PLAN COMMISSION AGENDA

TO: Village of Pewaukee Plan Commission
CC: Matt Heiser – Village Administrator, Jenna Peter - Clerk
FROM: Mark Lyons, Planning Consultant
RPT DATE: October 2, 2025
MTG DATE: October 9, 2025
RE: Christian Brothers Automotive CUG – Conditional Use Grant and Business Site Plan / Plan of Operation for an Automotive Service Use.

RE: Christian Brothers Automotive Site Plan Review – Capitol Drive, Pewaukee, WI 53072

TO: Village of Pewaukee Plan Commission
CC: Matt Heiser – Village Administrator, Jenna Peter - Clerk
FROM: Mark Lyons, Planning Consultant
RPT DATE: October 2, 2025
MTG DATE: October 9, 2025
RE: Bubble's Foam Farm –Planned Unit Development Request

SITE LAYOUT PLAN
C201

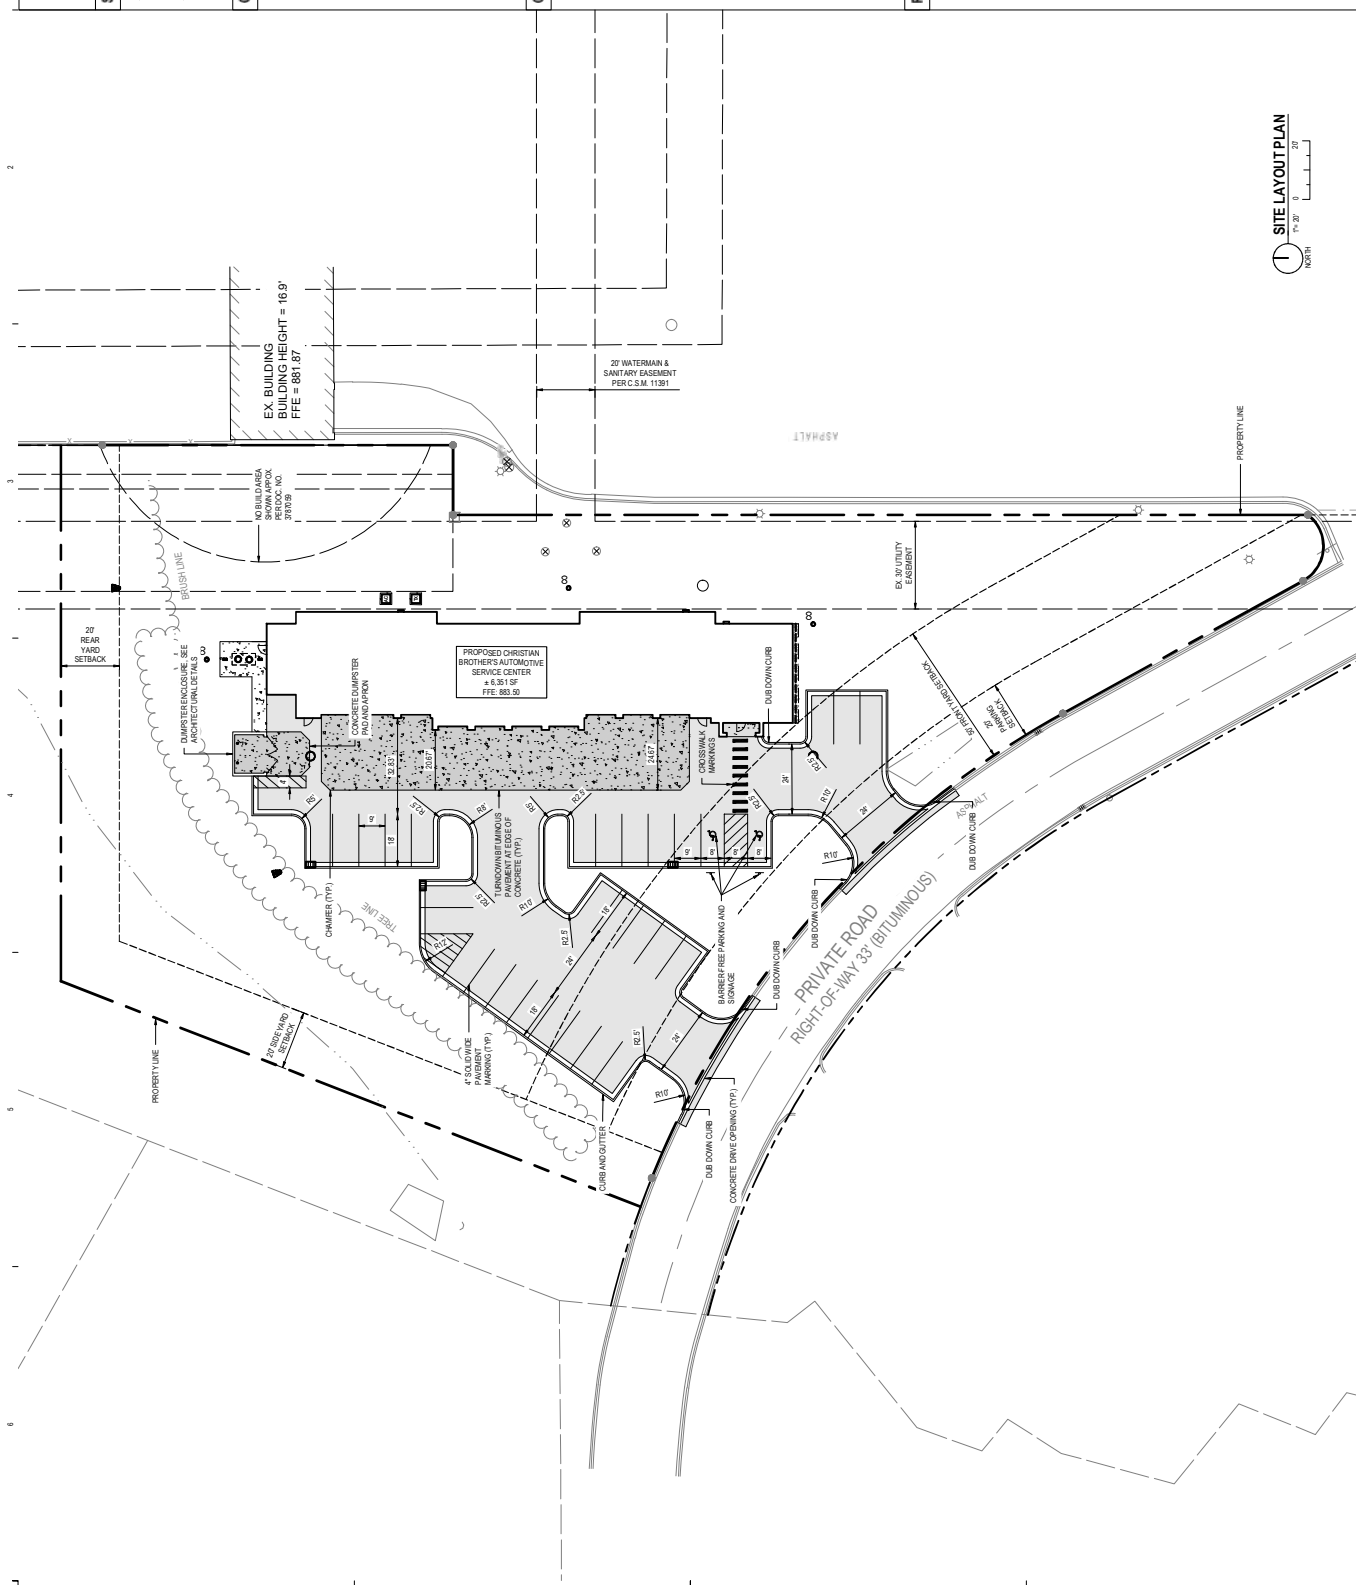
23. Provide silt fence along the east perimeter of the site to prevent erosion onto the adjacent property.
24. Clarify or provide a detail for "DUB DOWN CURB".

25. The drive aisle width in the west parking lot does not meet the minimum width per the Village Code. Revise the westerly parking lot to include a minimum drive aisle width of 25 feet.

Sheet C201 – Site Layout Plan

11. Clarify or provide a detail for “DUB DOWN CURB”.
12. The drive aisle width in the west parking lot does not meet the minimum width per the Village Code. Revise the westerly parking lot to include a minimum drive aisle width of 25 feet.

C-200

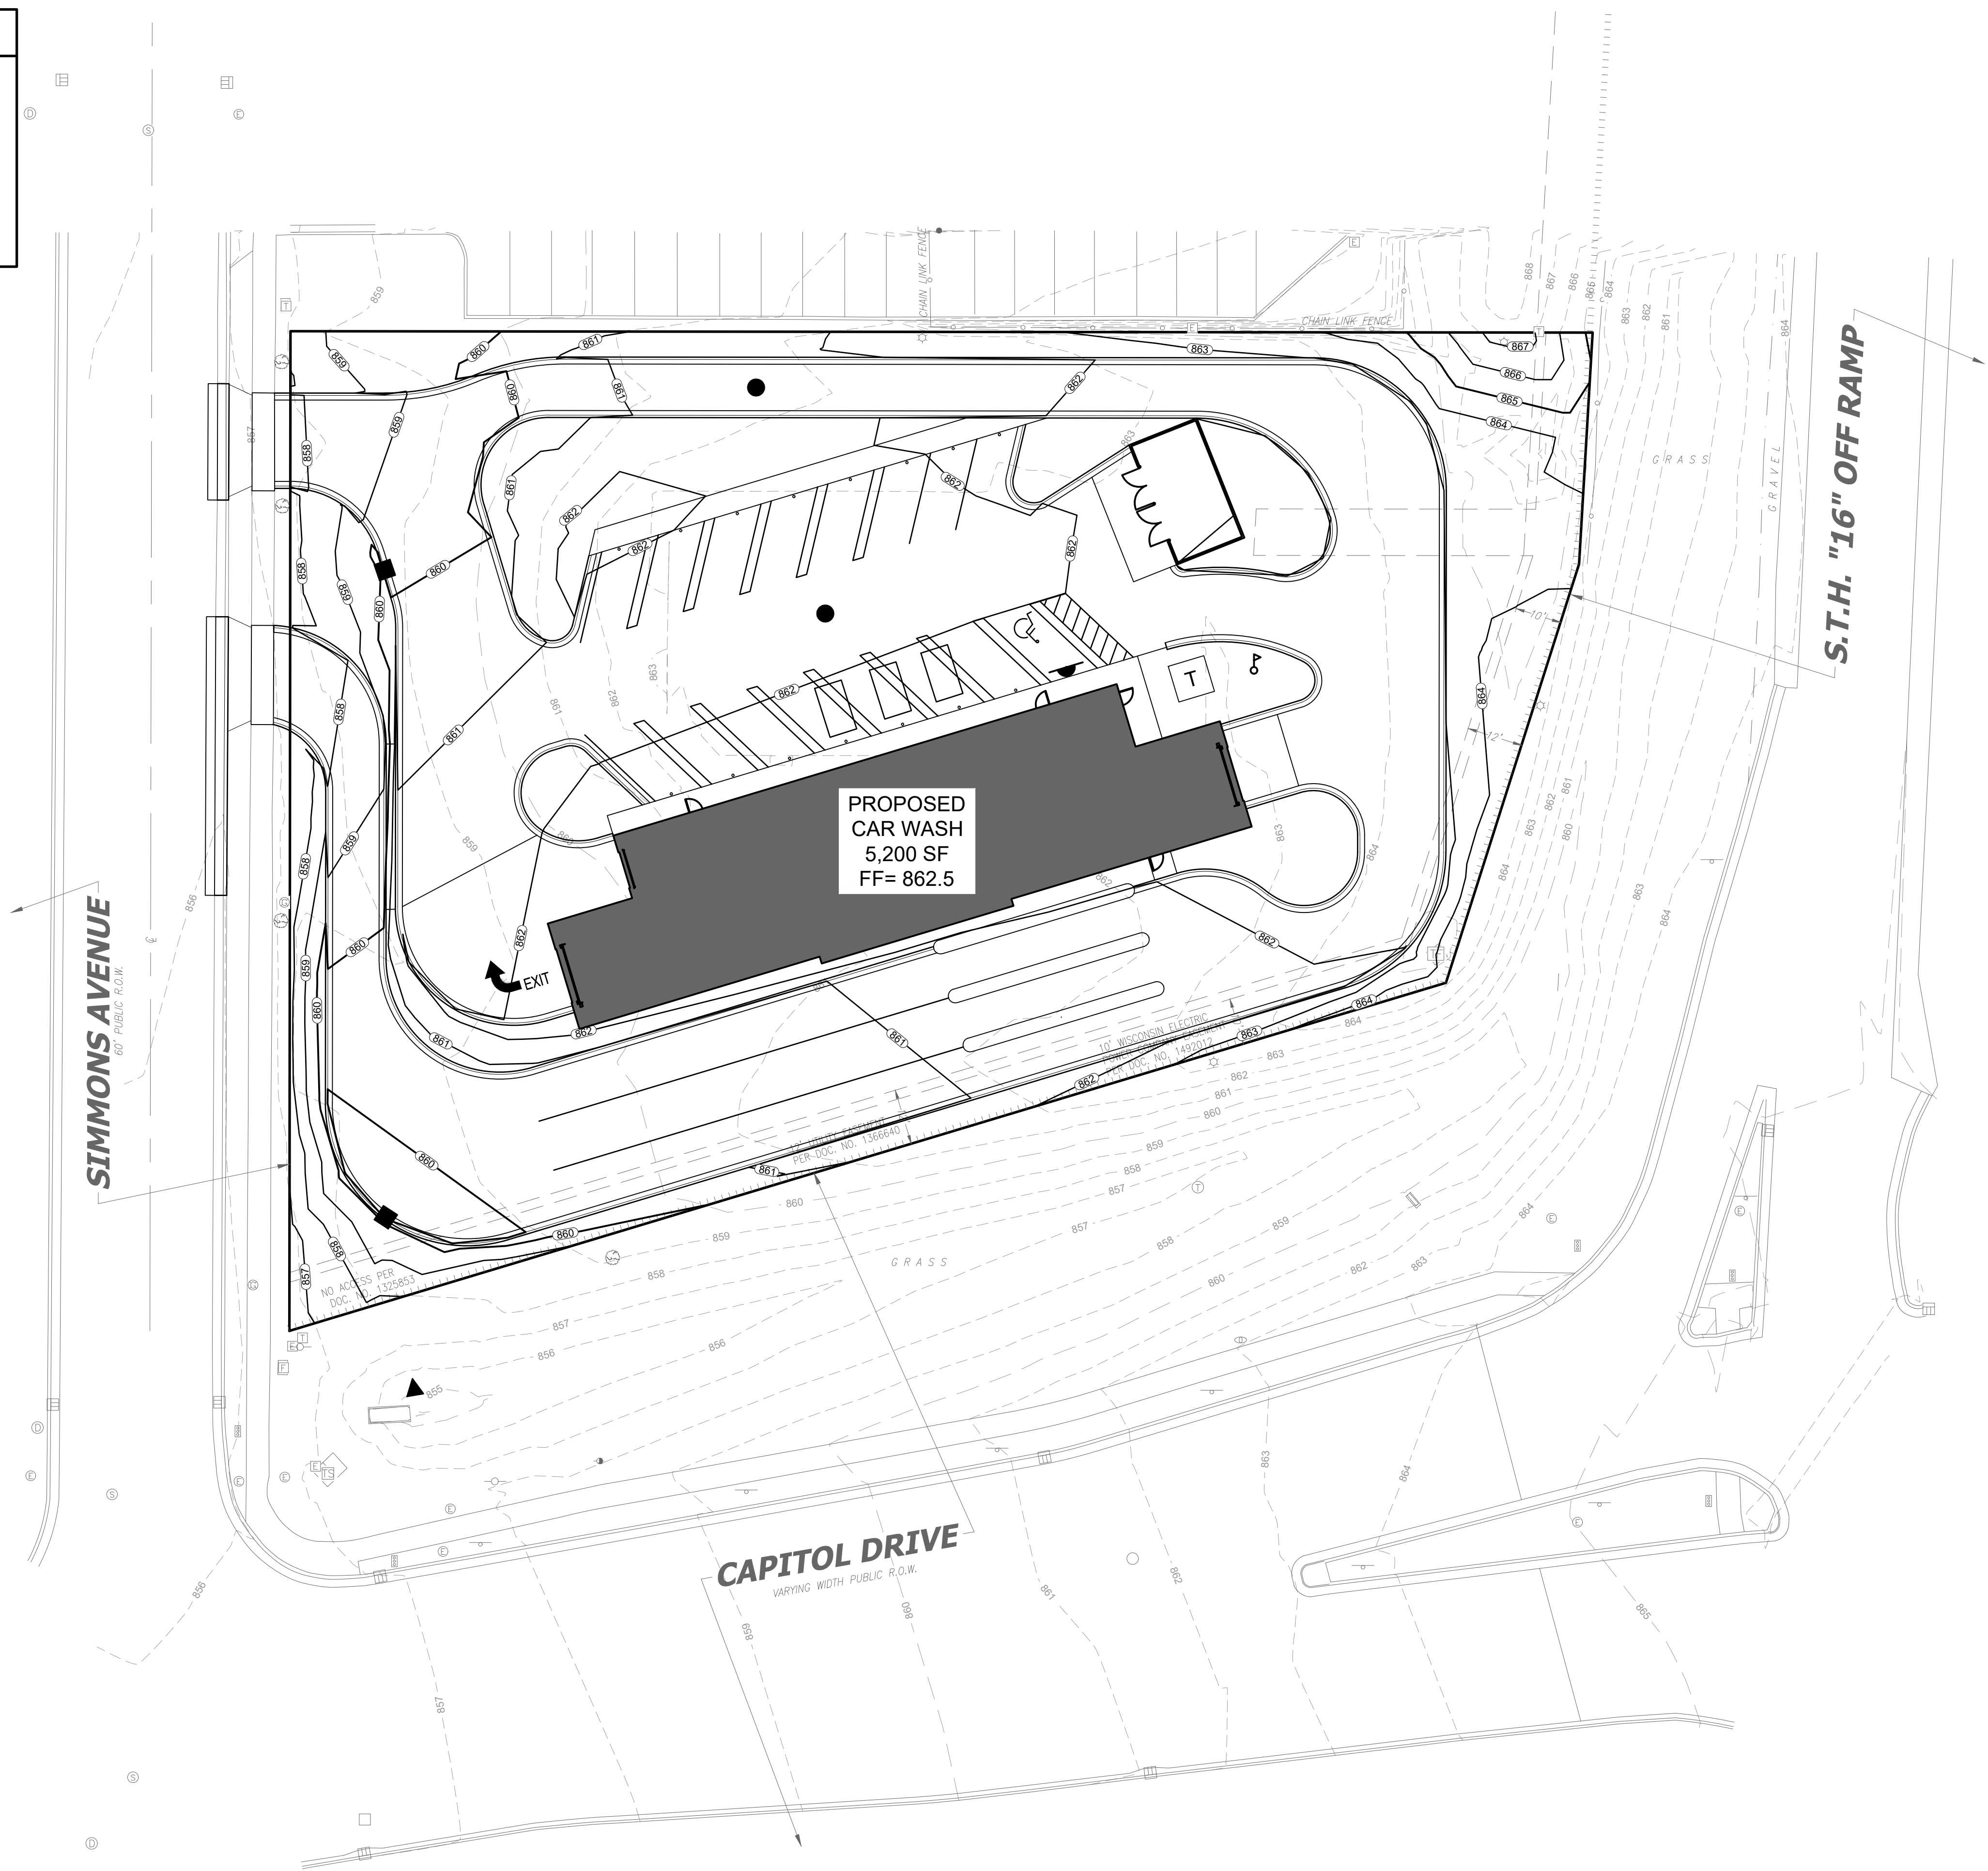
Sheet C-200 Site Plan
